# **Evaluation of the proposed AMEP compensation site at Cherry Cobb Sands**

**Roger Morris  
Bright Angel Coastal Consultants Ltd**

**29 July 2012**

**Contract title:**     **Evaluation of the proposed AMEP  
compensation at Cherry Cobb Sands**

**Figure 5.** Rates of saltmarsh development within Paull Holme Strays, 2003-2008 according to the topography of the site (based on mudflat elevation in 2005).

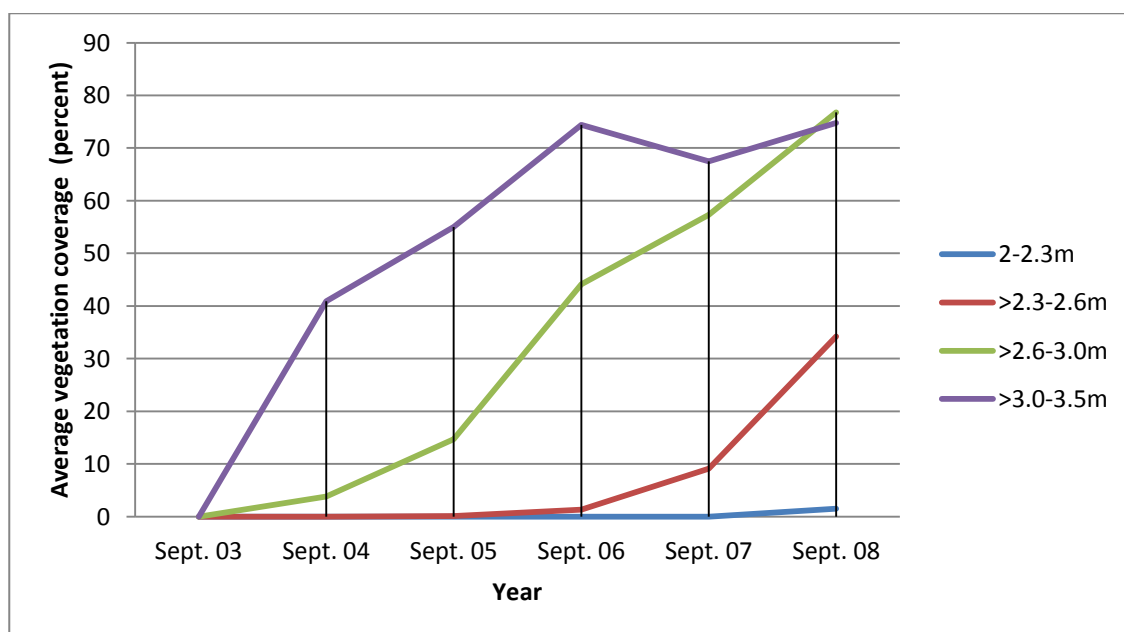
- 8.6. The Cherry Cobb Sands site is orientated broadly in the same way to that at Paull Holme Strays and Welwick and may therefore be expected to experience similar patterns of internally generated wave action and incoming wave activity through the breach. Thus, the wave climate is unlikely to result in any big difference in the rate of sediment remobilisation and so similar rates of sedimentation may be expected. Using data presented in Black & Veatch's own analysis (2011b) it might be expected that if the current land levels were to be maintained (i.e. around 2.5m OD) then between 34.2% and 76.8% of the site would have become saltmarsh over the first five years (Figure 5).

- 8.7. The site is fronted with a growing saltmarsh, suggesting that the local wave climate is sufficiently benign to facilitate mudflat and saltmarsh evolution. If it was more aggressive there would be evidence of foreshore lowering and the need to defend the toe of the flood defences. This does not appear to be the case at any point within the proposed site. This suggests that the site is highly suited to a realignment that will accrete rapidly.

**Figure 6.** The relative positions of the realignment site and mudflat whose loss it is intended to compensate for. Note that only the uppermost sections will be offset at the time of realignment and the important loafing/feeding areas (see photographs A1.3. to A1.5x in Appendix 1.) will be lost.

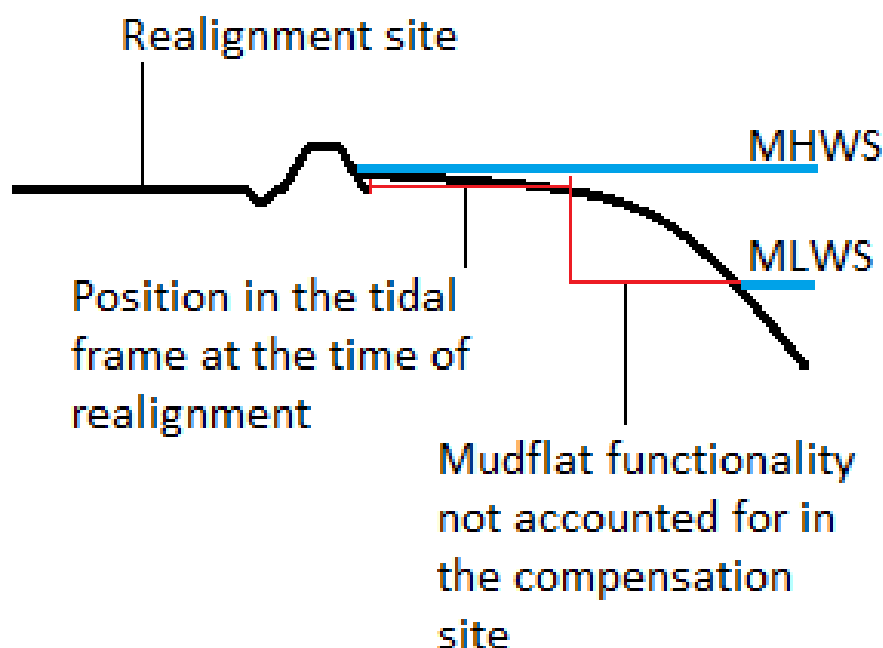
- 9.1.1. An open mudflat that extends from the drying zone above high water neaps down to extreme low water (Figure 6) will be replaced by an enclosed body of tidally inundated sediment. Open sightlines will be replaced by impeded sight lines, and the mudflats that are created will be exposed for the greater part of the tidal cycle, allowing them to de-water, consolidate and change in nature.

**Figure 7.** The relative positions of the realignment site after sedimentation and mudflat whose loss it is intended to compensate for. Note that the part of the foreshore that it replicates is much narrower and far greater functional losses will have happened.

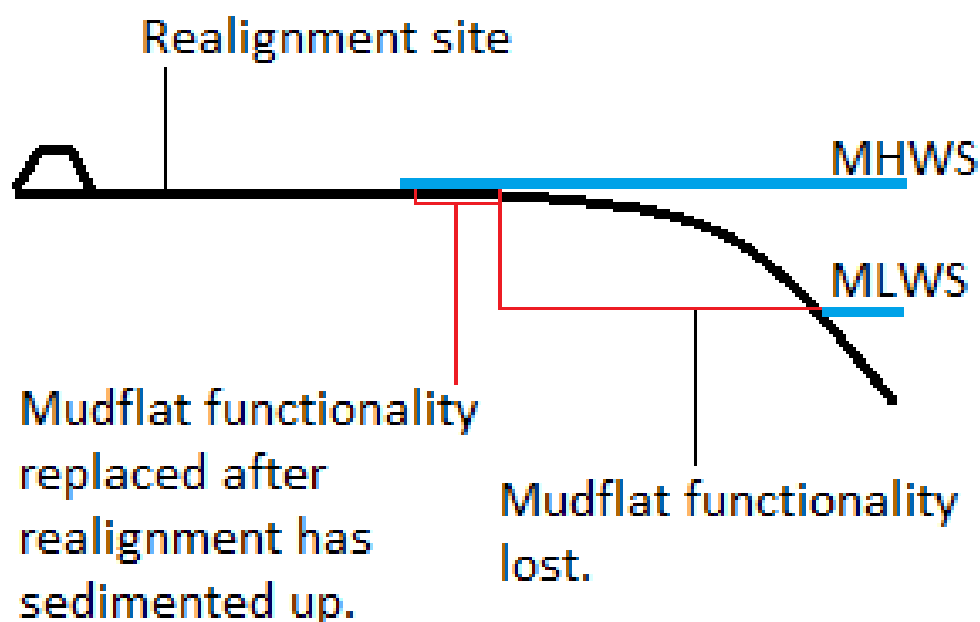
- 9.1.6. Managed realignment sites develop a relatively flat topography that supports organisms that favour the upper end of tidal influences (Figure 7). This topography and its benthos may be suitable for generalist waterfowl with short to medium beak lengths but it will be less appropriate for species such as Curlew, *Numenius arquata*, or Black-tailed Godwit whose bills are designed to seek prey deeper within the mud.
